**PROPOSAL FOR DRAFT AMENDMENT TO REGULATION No. 13
(O₁ and O₂ BRAKING SYSTEMS)**

This proposal needs to be considered with document ECE/TRANS/WP.29/GRRF/2008/25.

"Figure 5A: MECHANICAL-TRANSMISSION BRAKING SYSTEM
(See paragraph 2.3. of this Annex)

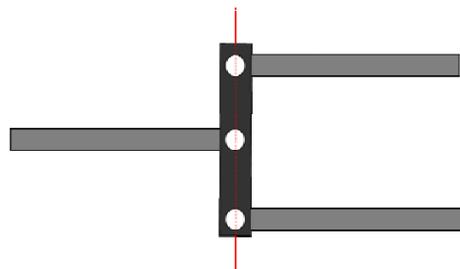
Insert new paragraphs 2.3.10. to 2.3.12. to read:

- 2.3.10. s_{cf} : Rear cable or rod travel at compensator when brakes operate in forward direction
- 2.3.11. s_{cr} : Rear cable or rod travel at compensator when brakes operate in rearward direction
- 2.3.12. s_{cd} : Differential travel at compensator when only one brake operates in the forward direction and the other in the reverse direction

Where $s_{cd} = s_{cr} - s_{cf}$ (See figure 5A Appendix 1)"

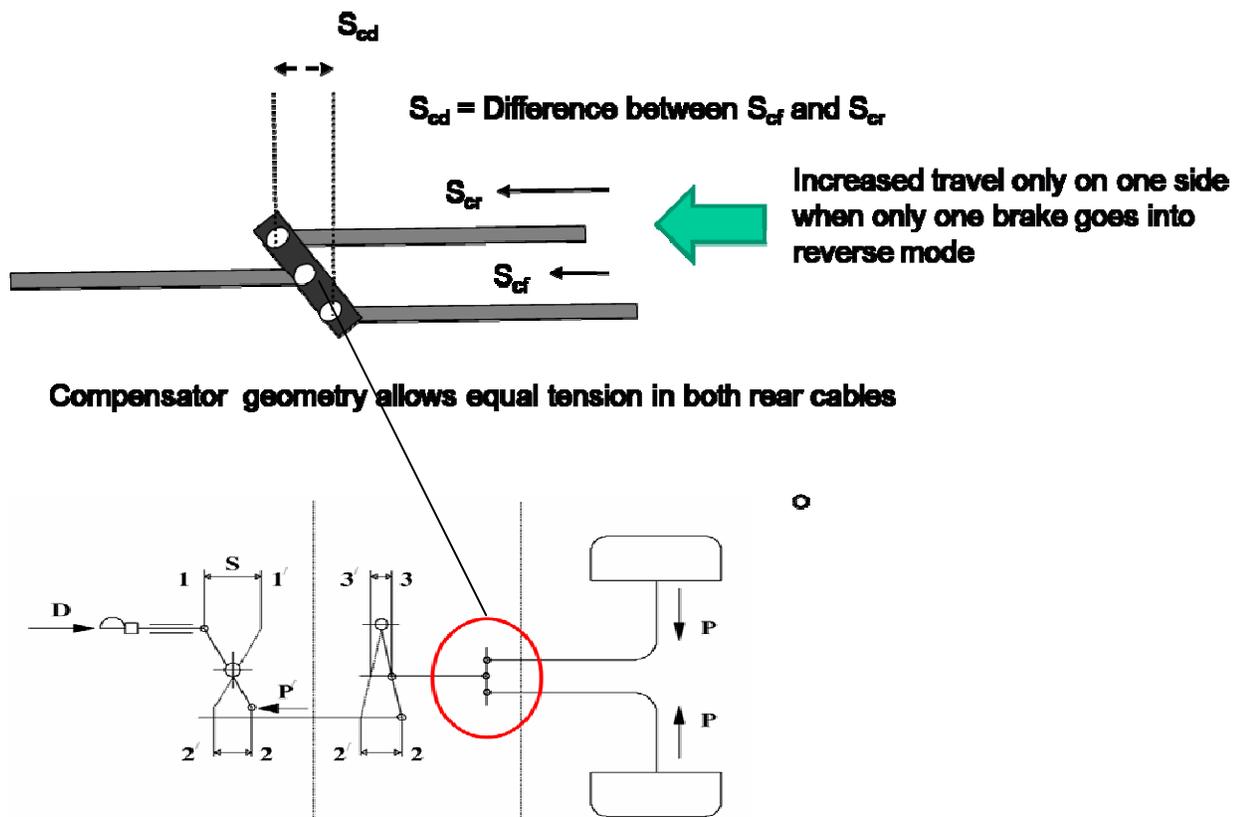
Insert new paragraphs 8.5. to 8.5.2. to read:

- "8.5. Alternative procedure for the simulated gradient parking brake force differential.
- 8.5.1. The pivot points in the compensator must lie in a straight line with the park brake at the rest position.

All compensator pivots to be in-line

Alternative arrangements can be used, if they provide equal tension in both rear cables, even when there are differences in travel between the rear cables.

8.5.2. Drawing details are to be provided to demonstrate that the compensator articulation is sufficient to ensure equal cable tension is applied to each of the rear cables. The compensator needs to have sufficient distance across the width to facilitate the differential travels left to right. The jaws of the yolks also need to be deep enough relative to their width to make sure that they do not prevent articulation when the compensator is at an angle.

Differential travel at compensator (s_{cd}) shall be derived from:

$$s_{cd} \geq 1.2.(s_{cr} - s_{c'})$$

Where $S_{c'} = S'/i_H$ (travel at compensator - Forward operation)

and $S_c' = 2S_B/i_g$

$S_{cr} = S_r/i_H$ (travel at compensator - Rearward operation)"

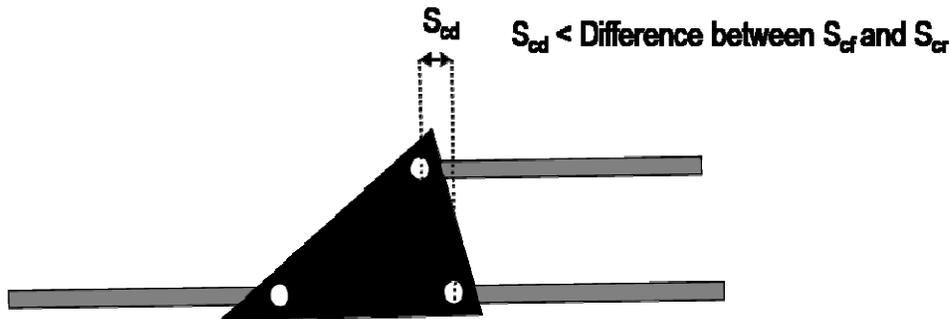
Insert new paragraphs 9. to 9.1.3. to read:

- "9. Differential travel at park brake compensator
- 9.1.1. Maximum permissible compensator travel (forward) $S_{cf} = \dots\dots\dots$ mm
- 9.1.2. Maximum permissible compensator travel (rearward) $S_{cr} = \dots\dots\dots$ mm
- 9.1.3. Maximum permissible differential compensator travel $S_{cd} = \dots\dots\dots$ mm"

Figure 2 Compensator operation

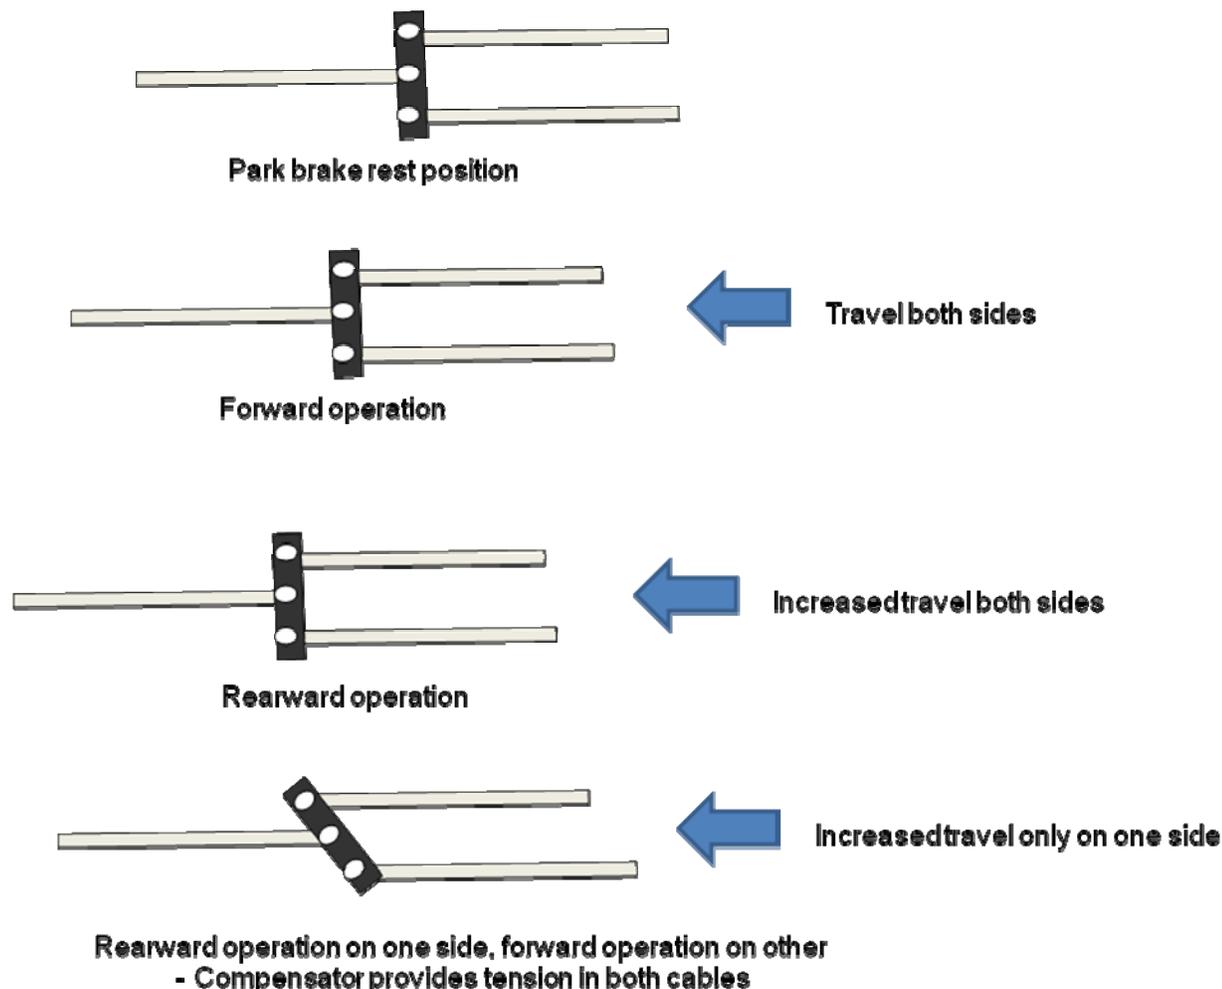
If the compensator design includes appropriate geometry, then both cables are subject to the same tension.

Figure shows the park brake operation of the compensator under various situations.

When the park brake is applied, the compensator applies tension to both rear cables. The compensator normally operates with either both brakes working in the forward or both in the reverse direction. However if one wheel is stopped from moving by an external force (e.g. held against the kerb), then one brake can remain in the forward operating direction and the other will move into the reverse mode. This results in different travels in the left and right cables. The compensator must tilt to ensure that both cables are still held under the appropriate tension. This is shown in the last diagram Figure .
